## PLANNING REPORT

# Architectural Review Board

## 55 S. RIVERVIEW STREET MPR and DEMOLITION/LANDMARK and WAIVERS 24-014MPR and 24-017DEMO

### Case Summary

Before

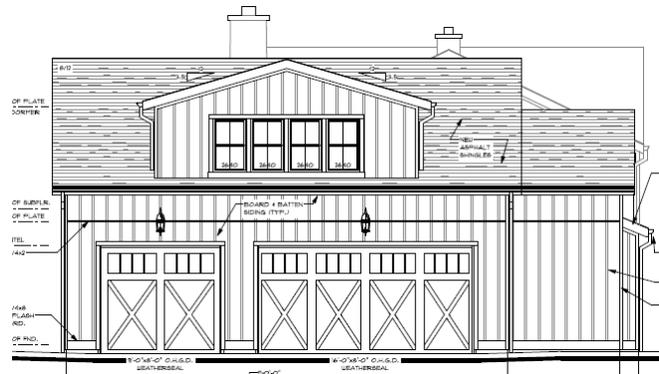
This elevation faces S. Riverview Street and is the front of the house. In 1991, a new porch was added with decorative columns, brackets, and spindle frieze seen below. The owners desire to add more detail to the house, and the existing porch appears under-supported, so

staff suggested that an additional column and brackets would be appropriate. The new elements will exactly match the existing elements.
